PCD File No. PPR-21-

**SADDLEHORN RANCH**  
OVERALL WATER SYSTEM  
NORTH/SOUTH BUILDING ELEVATIONS

**SADDLEHORN RANCH**  
 OVERALL WATER SYSTEM  
 EAST/WEST BUILDING ELEVATIONS

**SADDLEHORN RANCH**  
**OVERALL WATER SYSTEM**  
**WATER STORAGE TANK**  
**PLAN & ELEVATIONS**

**NORTH ELEVATION**

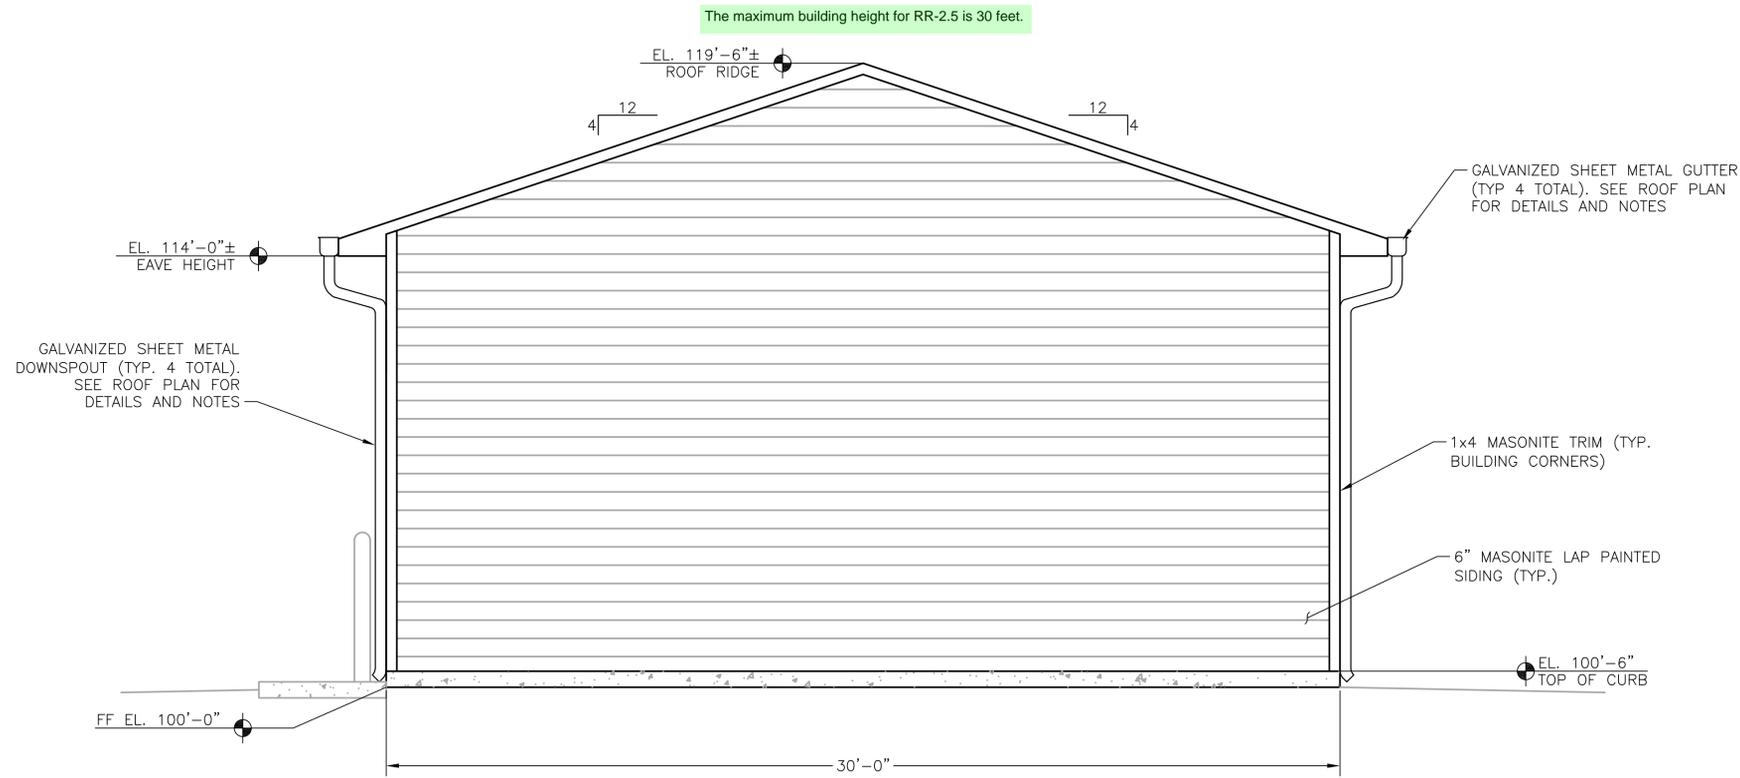
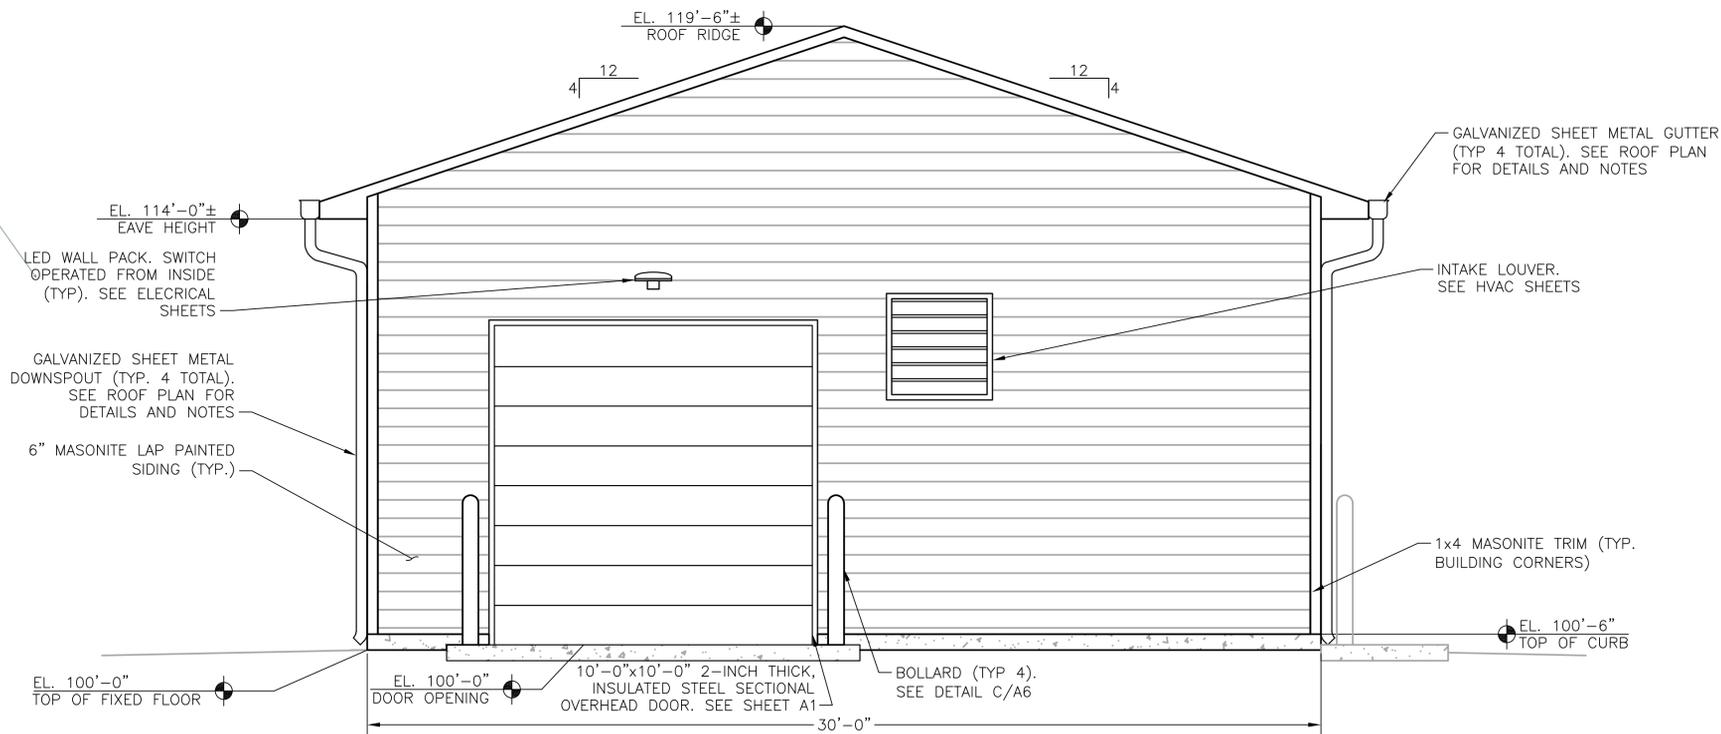
Add height dimension for light fixture

add project number to all pages
